The Commission has issued the enclosed Amendment No. to Provisional Operating License No. DPR-19 for Dresden Station Unit 2 and Amendment Nos. and to Facility Operating License Nos. DPR-29 and DPR-30 for Quad Cities Station Units 1 and 2, respectively. The amendments are in response to your letter of March 19, 1980.

The amendments establish MAPLHGR limits for standard 8x8 (8D250 and 8D262) fuel types for exposure values beyond those currently given in the Technical Specifications.

AMENDMENT TO PROVISIONAL OPERATING LICENSE

SAFETY EVALUATION BY THE OFFICE OF NUCLEAR REACTOR REGULATION
SUPPORTING AMENDMENT NO. 50 TO PROVISIONAL OPERATING LICENSE NO. DPR-19,
AMENDMENT NO. 59 TO FACILITY OPERATING LICENSE NO. DPR-29, AND
AMENDMENT NO. 54 TO FACILITY OPERATING LICENSE NO. DPR-30

FIGURE 3.5-1
(Sheet 1 of 5)

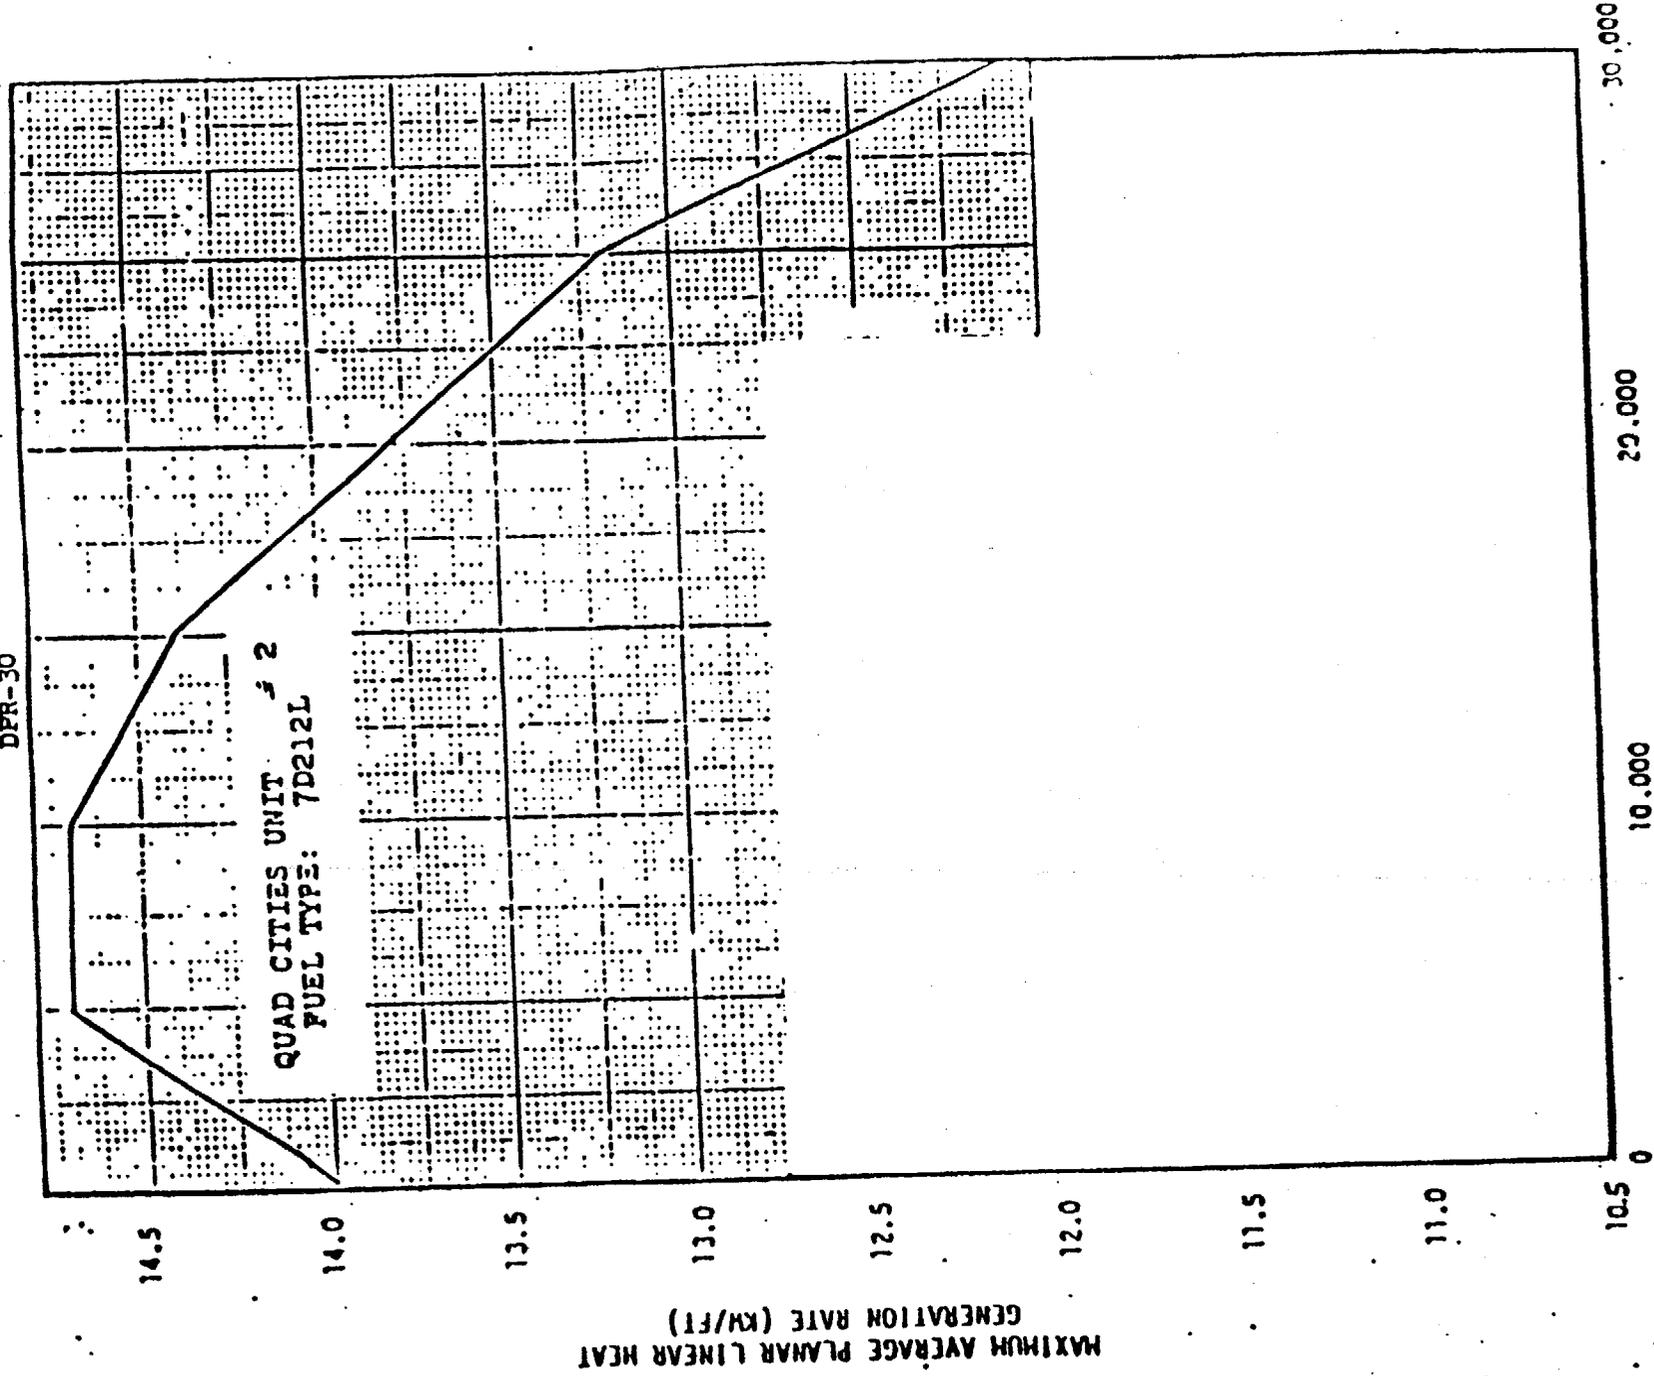
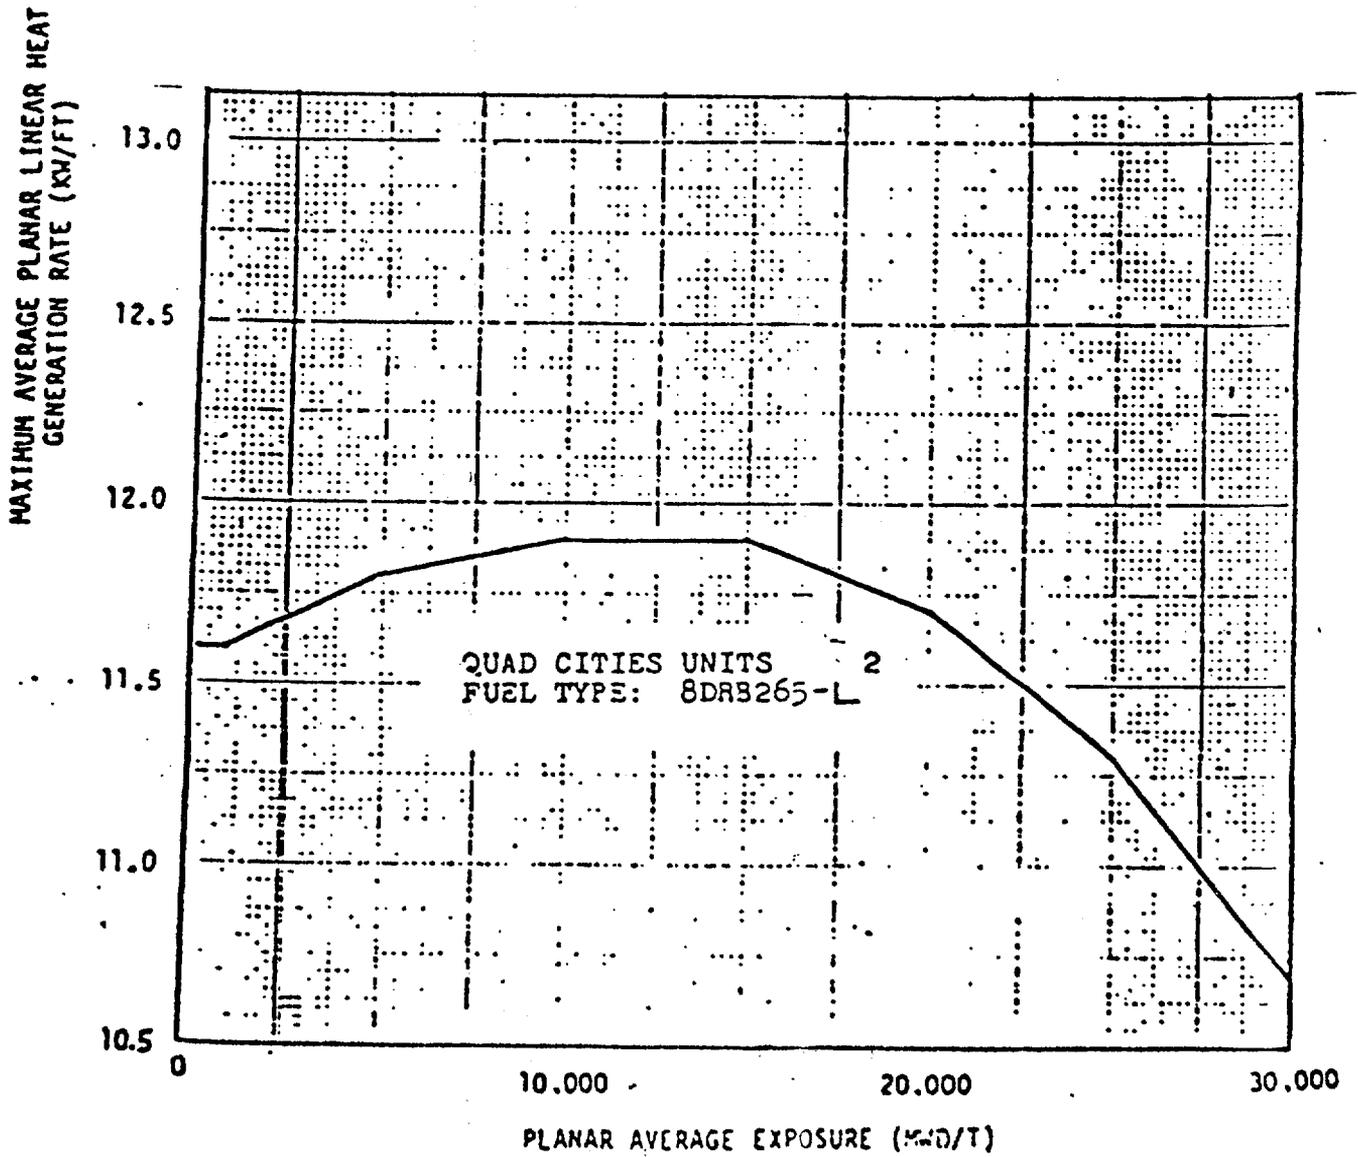
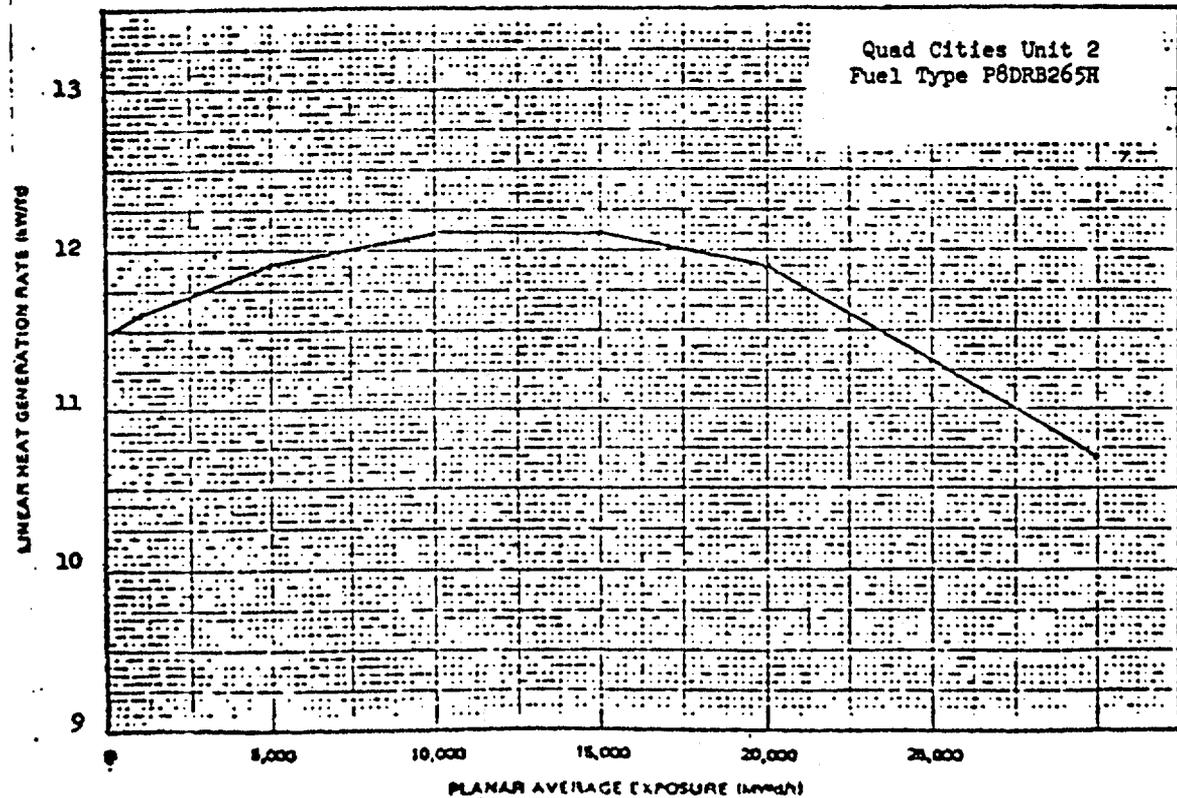
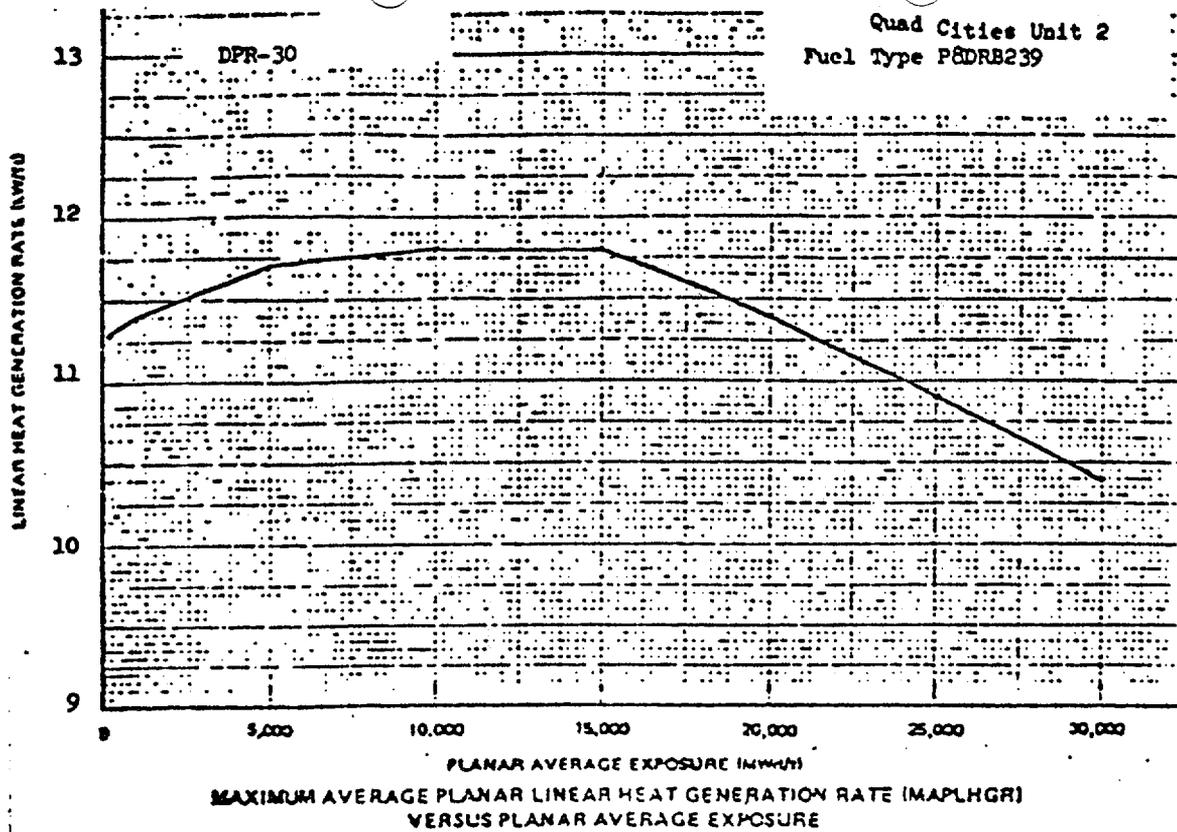
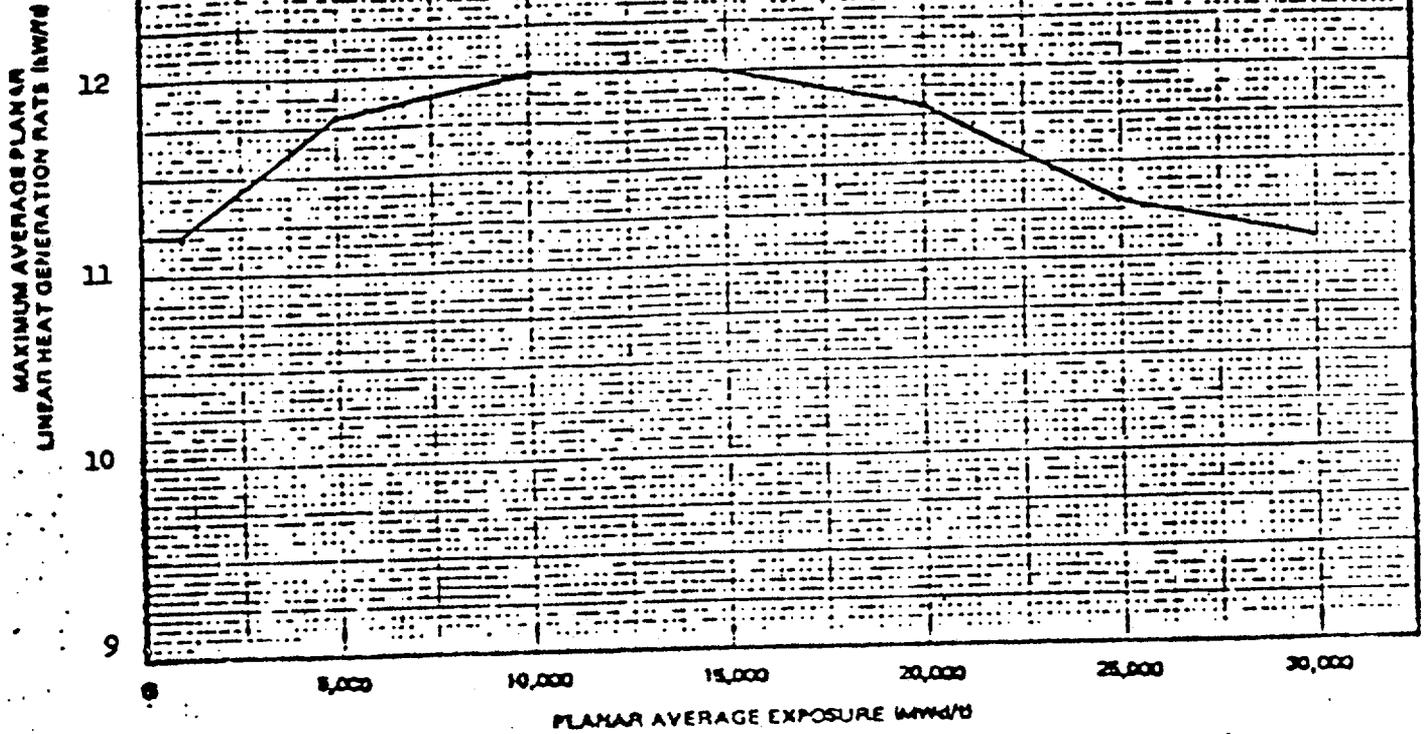
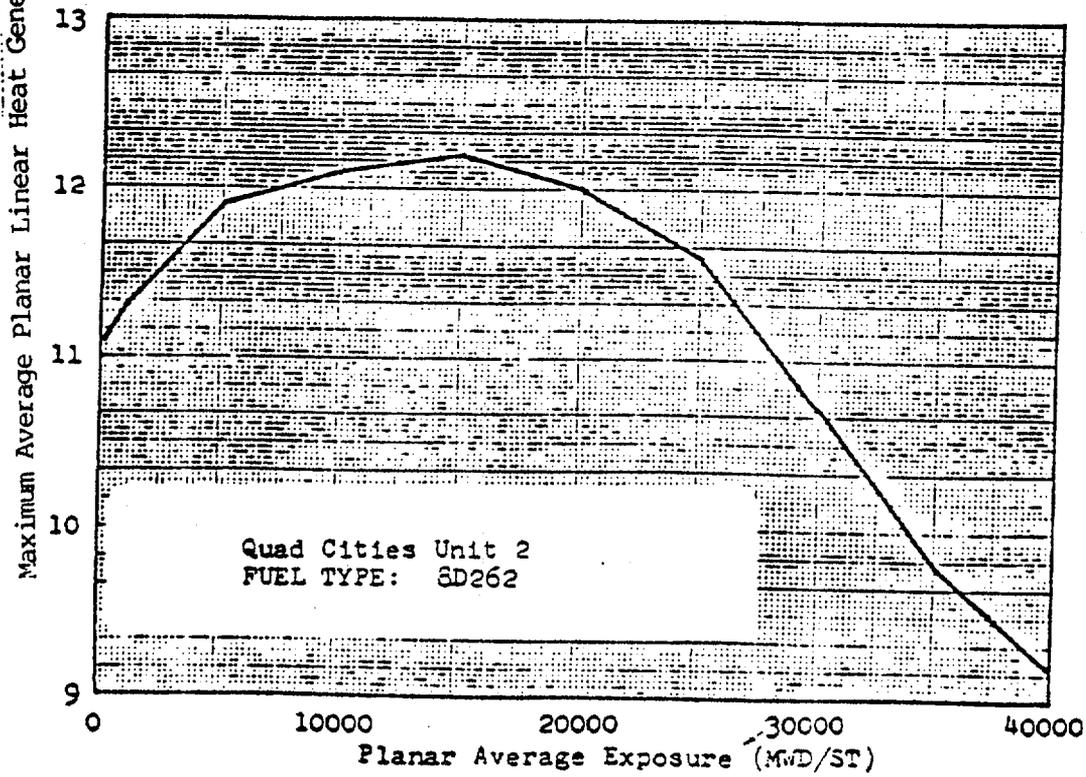
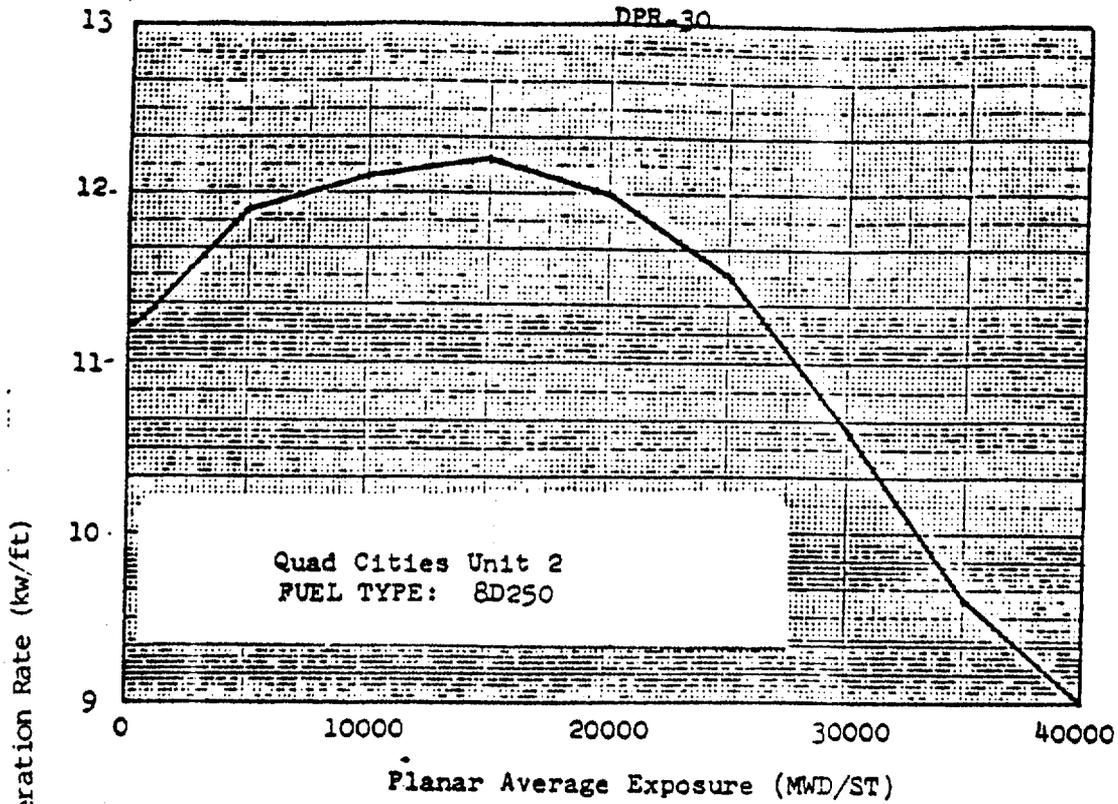
Revise the Appendix "A" Technical Specifications as follows:

Figure 3.5-1 (Sheet 1 of 4)
Figure 3.5-1 (Sheet 2 of 4)
Figure 3.5-1 (Sheet 3 of 4)
Figure 3.5-1 (Sheet 4 of 4)

Figure 3.5-1 (Sheet 1 of 5)
Figure 3.5-1 (Sheet 2 of 5)
Figure 3.5-1 (Sheet 3 of 5)
Figure 3.5-1 (Sheet 4 of 5)
Figure 3.5-1 (Sheet 5 of 5)
